2X660 MW UDANGUDI SUPERCRITICAL TPS, STAGE-I

ARCHITECTURAL DRAWING CONTROL ROOM BUILDING (PLAN)

TB-1-400-607-620-1

400 KV SWITCHYARD AT UDANGUDI SUPERCRITICAL TPS STAGE-I (2X660 MW)		
Clarification for & ARCHITECTURAL DRAWING CONTROL ROOM BUILDING (PLAN)		
BHEL Ref. No.: CLAR/PNK/24.09.19		
BHEL DWG/DOC NO.:	TB-1-400-607-620-1	DATE OF SUBMISSION OF REVISED DOCUMENTS
DWG/DOC NAME:	ARCHITECTURAL DRAWING CONTROL ROOM BUILDING (PLAN)	24.09.19
SL. NO.	Comments From TCE	BHEL Clarifications.
1	FURNISH KEY PLAN	Incorporated
2	FOLLOWING ITEMS TO BE PROVIDED AS PER SPECIFICATION ENGINEERING ROOM,TARIFF METERING ROOM	Engineering room is already provided on first floor marked as EWS room (Engineering workstation room). We are placing 2 no. Tariff metering panels in Relay panel room only hence no separate room is required. This is already approved in conceptual control room building layout: TB-2-400-316-004-Rev 01.
3	LIFTING ARRANGEMENT FOR PANELS ON FIRST FLOOR WITH HATCH OPNG.	Lifting arrangement provided in revised drawing. Panels can be lifted using EOT crane and unloaded on platform at grid 1 between C & D.

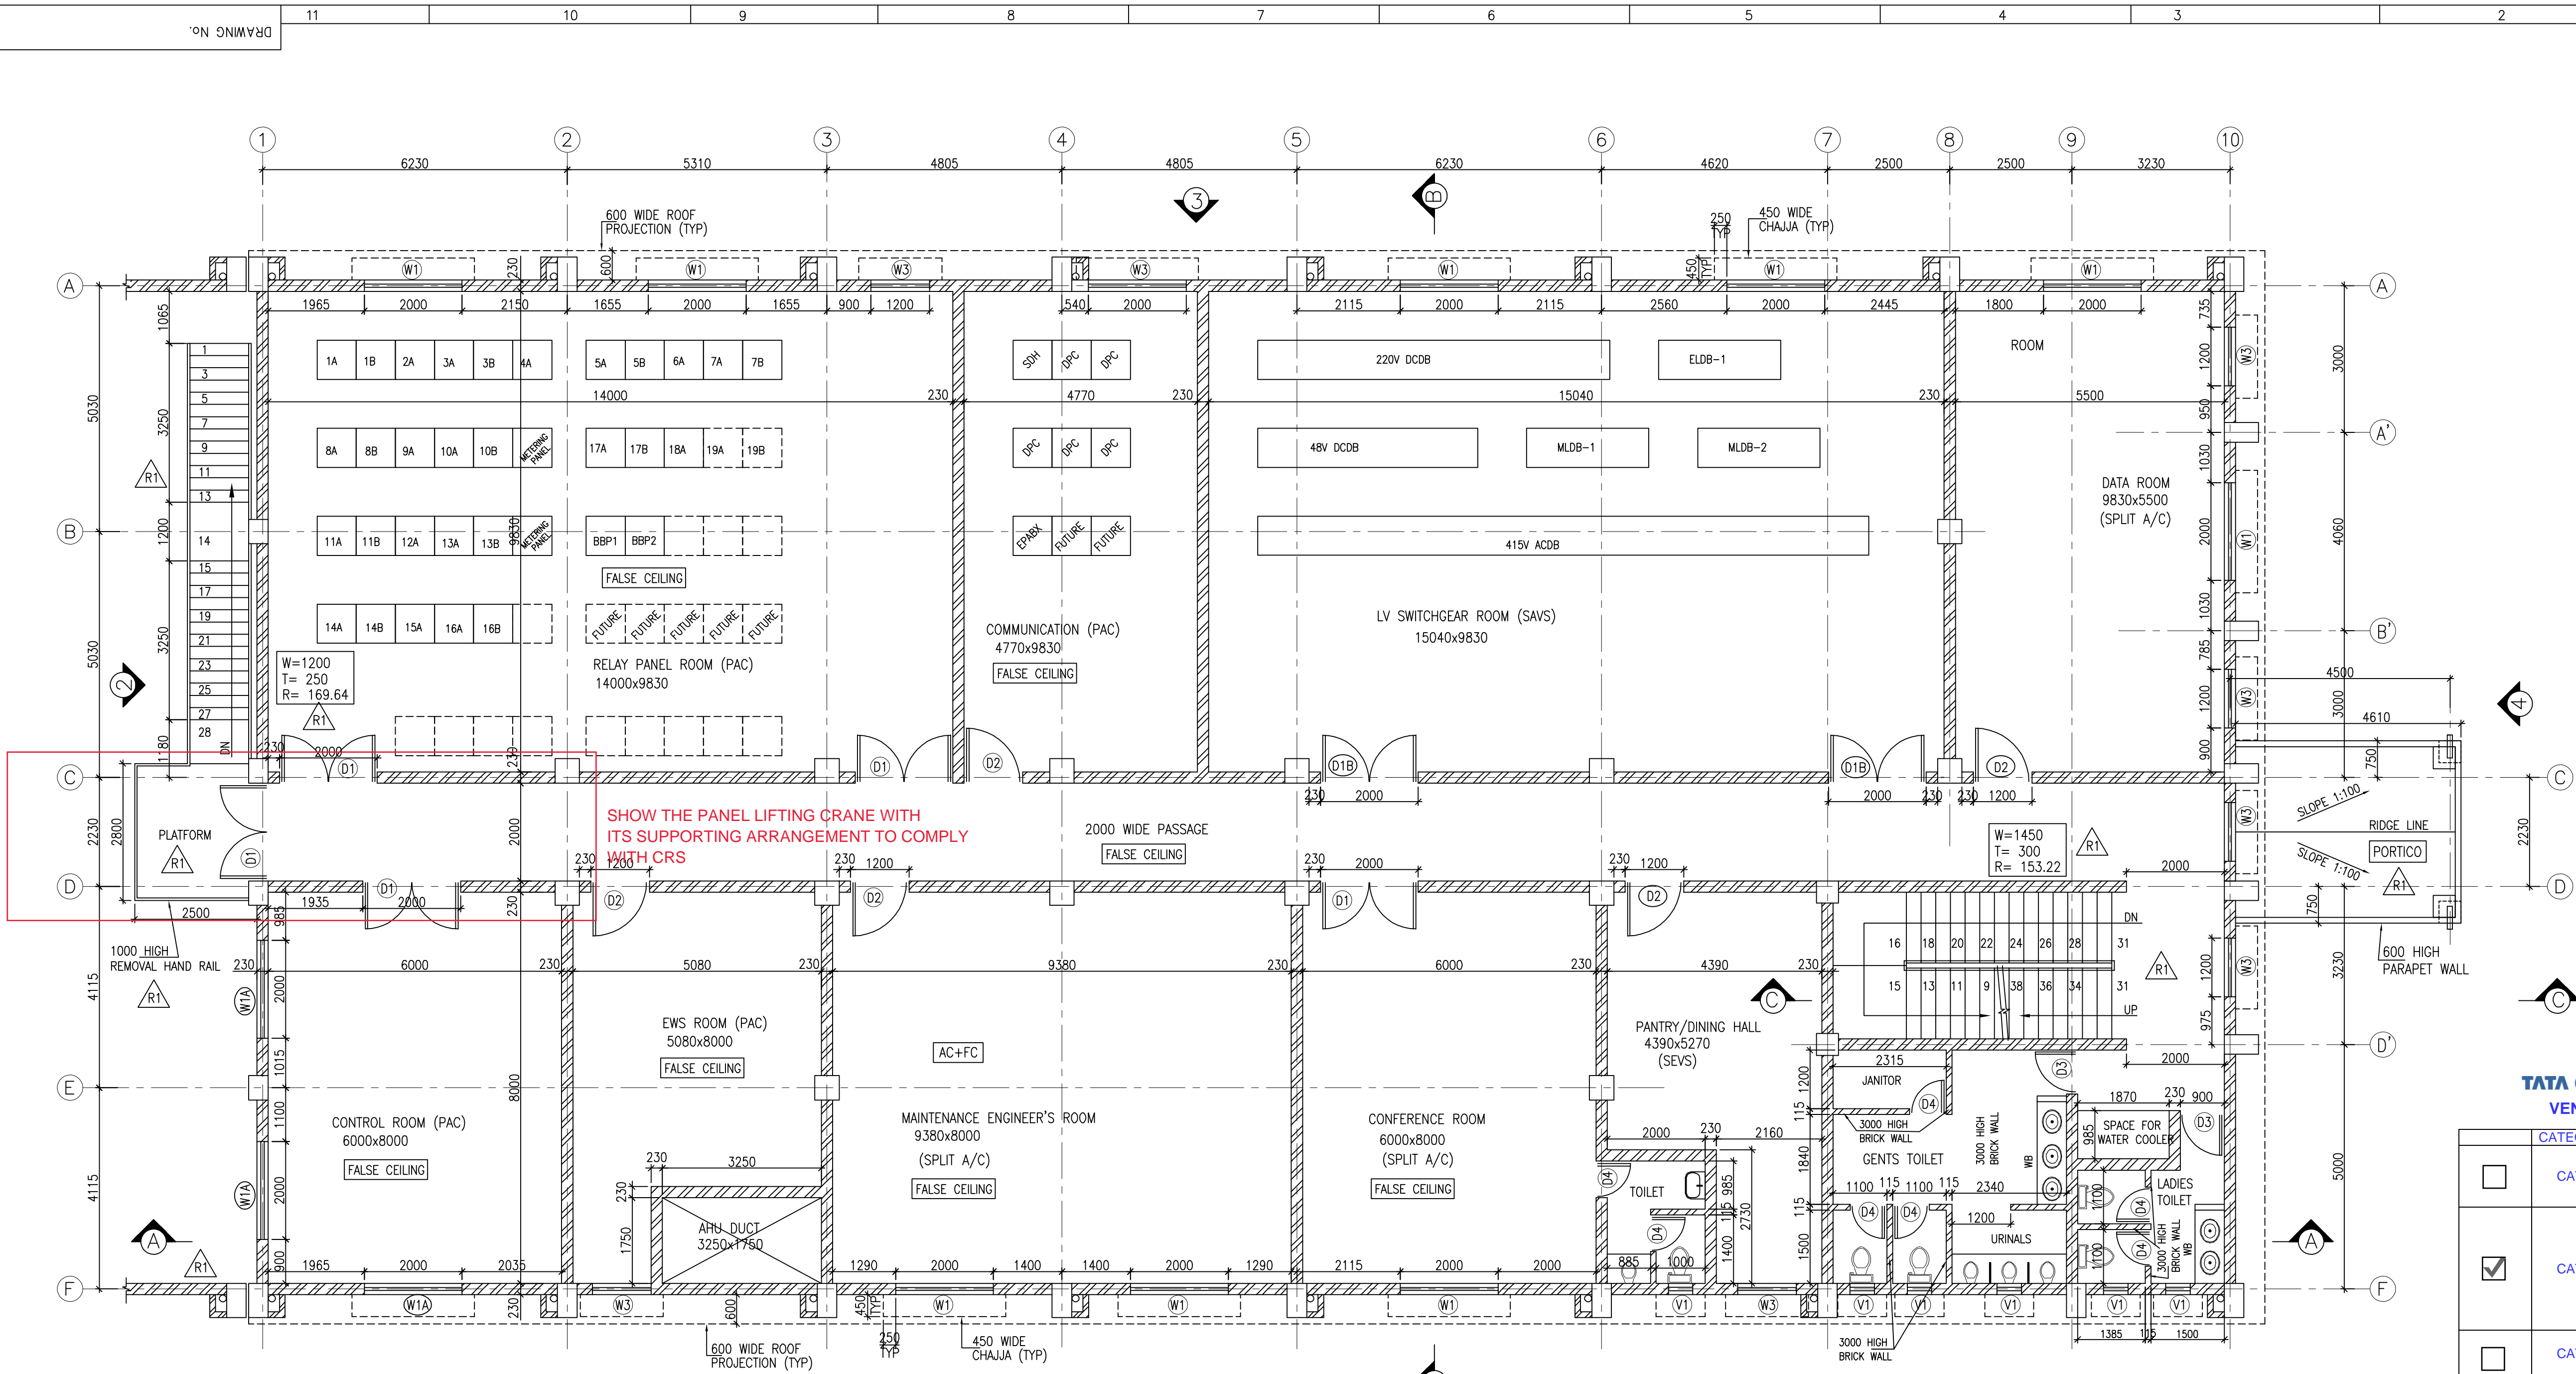
4	CONTROL ROOM ON SWITCHYARD SIDE TO HAVE FIXED WINDOWS	Incorporated
5	CHECK AND CONFIRM THAT ALL REQUIREMENTS, FIXTURES, TYPES AND FINISHES ARE AS PER SPECIFICATION REQUIREMENT	Confirmed
6	FINISH SCHEDULE IS MISSING	Finishing schedule shall be submitted separately with drg no-TB-1-400-607-621
7	DOOR & WINDOW -CHECK&CONFIRM THAT THIS MEETS THE SPECIFICATION REQUIREMENTS	Confirmed
8	AIR CONDITIONED AREAS TO HAVE AIR TIGHT LOBBY AND SLIDING DOOR	Air tight lobby with sliding doors are used only where the complete building is centralised air conditioned and frequent open/closing of main entrance doors of relatively bigger size due to which bigger volume of air change happens between air conditioned atmosphere and outside environment. Hence this concept is not applicable for switchyard control building where we have ductable Package AC unit for relay panel room, EWS and Communication room at first floor & nowhere these areas are directly exposed to outside atmosphere. Hence we have provided air tight doors as per standard practice. Also all the air conditioned related design to meet required temperature & humidity shall be done accordingly with sufficient margin and performance of the same shall be guaranteed during PG test separately

TANGEDCO COMMENTS		
1	Passage width shall be 2.1m	Passage width Shall remain 2.0 m .Matter has been discussed with customer over phone
2	Staircase rise shall be 150mm and thread 300mm and width of flight shall be 1500	Incorporated.
3	Battery room shall be provided with exhaust and ventilator	Incorporated.
4	Provide 2 nos of windows of 1.5m width in battery room	Incorporated.
